UNITED STATES PATENT AND TRADEMARK OFFICE

APPLICATION NO.	FILING DATE	FIRST NAMED INVENTOR	ATTORNEY DOCKET NO.	CONFIRMATION NO.
10/519,743	08/25/2005	Sergio Debernardi	9526-47	9279
30448 7590 07/16/2008 AKERMAN SENTERFITT P.O. BOX 3188 WEST PALM BEACH, FL 33402-3188				
EXAMINER				
WU, IVES J				
ART UNIT		PAPER NUMBER		
1797				
MAIL DATE		DELIVERY MODE		
07/16/2008		PAPER

Office Action Summary**Application No.**

DETAILED ACTION***Drawings***

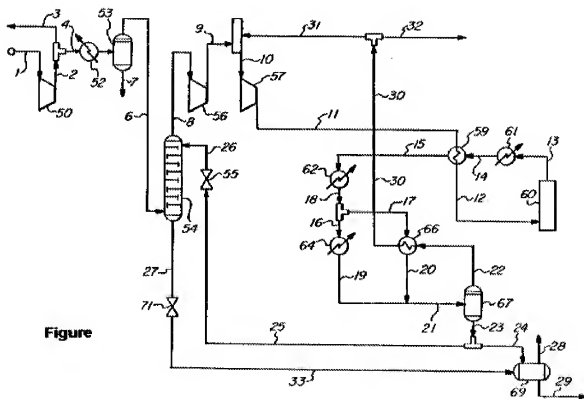
As to Method for ammonia production through a catalytic reaction of pressurized synthesis gas in an appropriate compressor with many stages, each of which is equipped with an inlet and outlet for synthesis gas, which method includes a purification step through liquid ammonia of synthesis gas from water and carbon dioxide contained in it in **independent claim 1**, Moore (WO 01/66465A1) discloses ammonia synthesis process and apparatus for use therein (Title). As illustrated in the following diagram, which include several stages of compression and inlet, outlet for each compressor, a dehydrator 54 with liquid ammonia from line 25 to contact synthesis gas from line 6 for purification.

As to step of arranging a gas-liquid mixer in fluid communication, on one side with the outlet of 1st stage of compressor or with the outlet of an intermediate stage thereof and, on the other side, with the inlet of a stage immediately following 1st stage or intermediate stage, mixer having a portion of reduced cross section, extending for a prearranged axial length in method in **independent claim 1**, Moore (WO 01/66465A1) discloses dehydrator 54 to be one of any

As to cooling to be carried out upstream of the inlet of coaxial flows of synthesis gas and of liquid ammonia in mixer in **claim 4**, as shown in the Figure of Moore, the cooling is upstream of the inlet to the dehydrator.

As to at least one cooling group being placed between mixer and 1st stage of compressor in **claim 9**, the Figure of Moore shows the cooling group 52 between mixer and 1st stage compressor.

Fig. 6

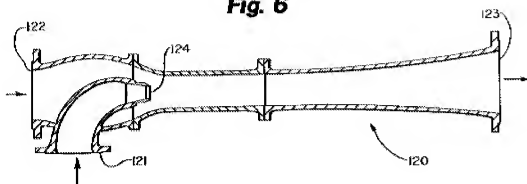
As to step of axially feeding into mixer a flow of synthesis gas outbound from 1st stage or from intermediate stage at the same time as a flow of liquid ammonia flows being coaxial and in co-current in method in **independent claim 1**, as illustrated in Figure 6 of Torkildsen et al (WO 99/13963), which reads on this limitation of instant claim.

As to flow of liquid ammonia being fed into mixer in the form of a plurality of high speed jets in **claim 5**, Torkildsen et al (WO 99/13963) disclose the jet pump 120 in Figure above, which would generate jet of liquid droplets (page 2, line 13-14, page 10, line 6-15). It would be obvious to have plurality of high speed jets arranged because duplication of parts is obvious. *In re Harza*, 274 F.2d 669, 124 USPQ378 (CCPA 1960).

As to flow of liquid ammonia being fed into mixer making it pass through a nozzle equipped with appropriate suitably sized openings or slits in **claim 6**, the Figure 6 above of Torkildsen et al would read on the instant claim - nozzle.

As to nozzle equipped with appropriate suitably sized openings or slits in fluid communication on one side with portion of reduced cross-section of mixer and on the opposite side with a line for feeding a flow of liquid ammonia into mixer in **claim 10**, Torkildsen et al (WO 99/13963) disclose the jet pump to generate the liquid droplets page 2, line13-14) together with the Figure 6, which reads on the instant claim.
